RE: **RMCI Office & Shop**  
**5440 Watson Dr SE**  
**Grading and Drainage Plan Stamp Date: 12/6/19**  
**Hydrology File: Q16D007**

Based on the submittal received on 12/9/19, the above-referenced Grading and Drainage Plan is approved for Grading Permit.

ROUGH  
GRADING  
PLAN  
&  
DRAINAGE  
ANALYSIS

C100

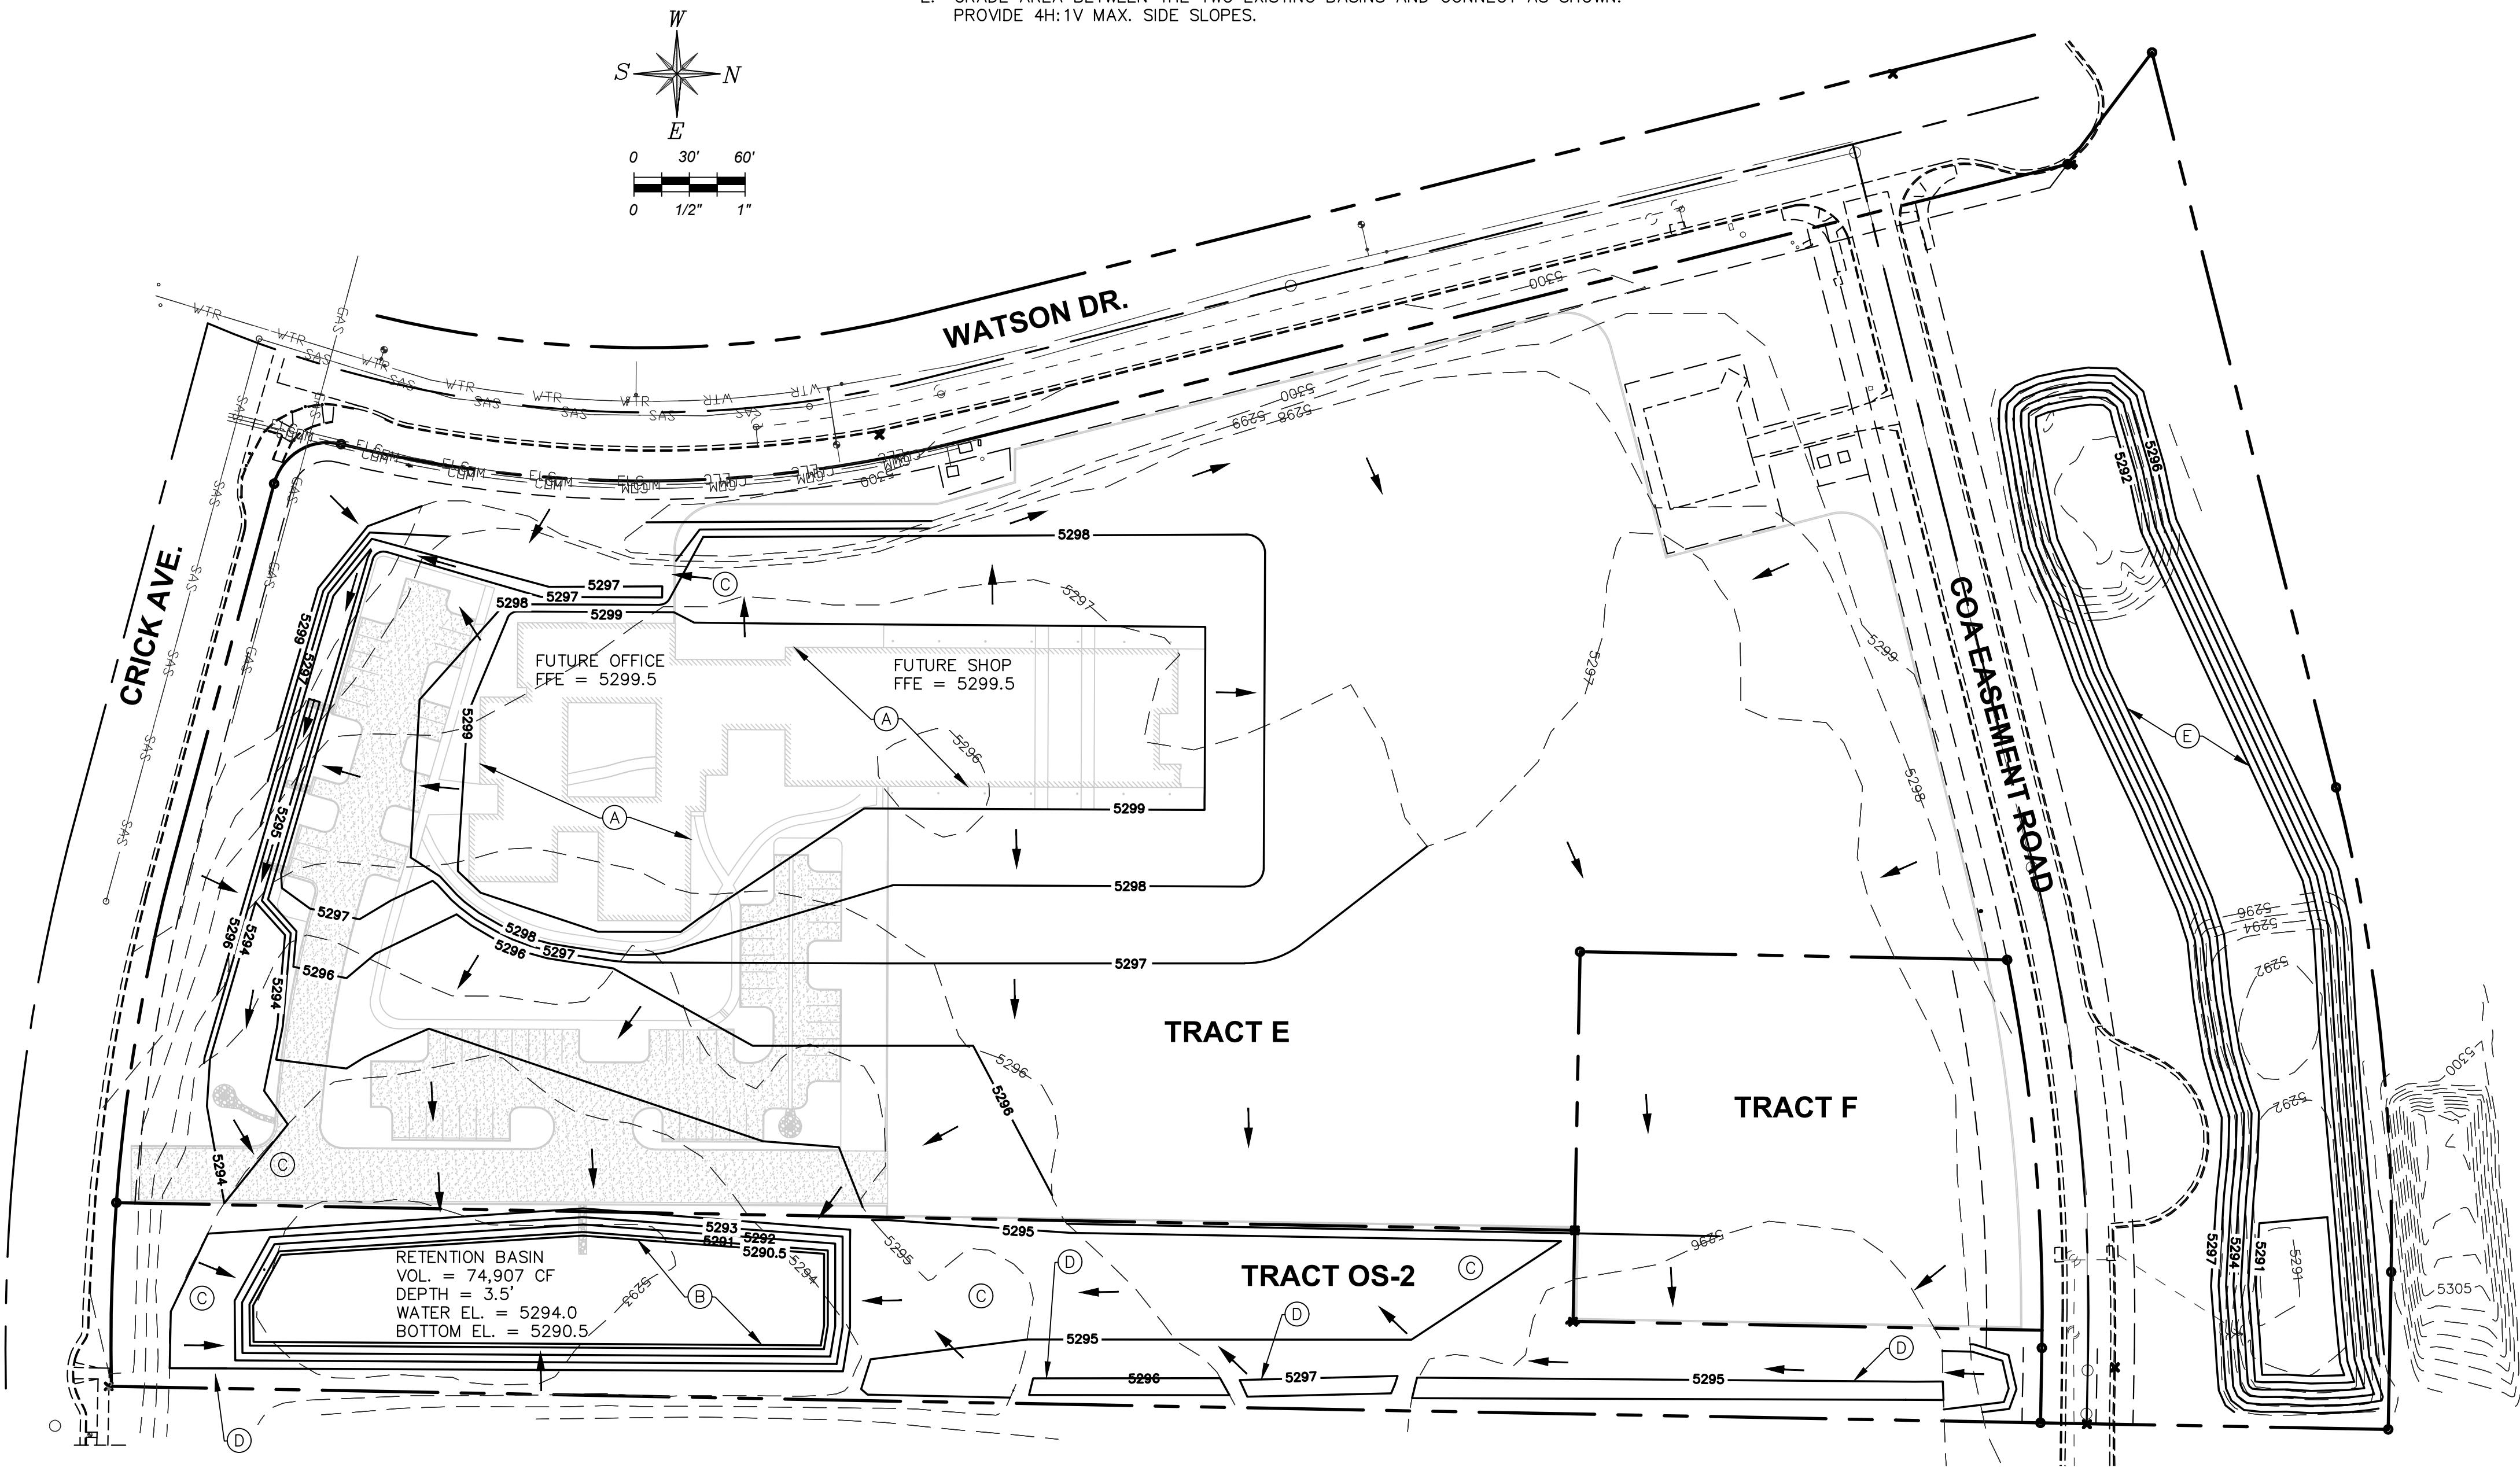
1. An updated Grading and Drainage Plan will be required to account for the building construction and addition of impervious cover; major infrastructure may also be required at this time.
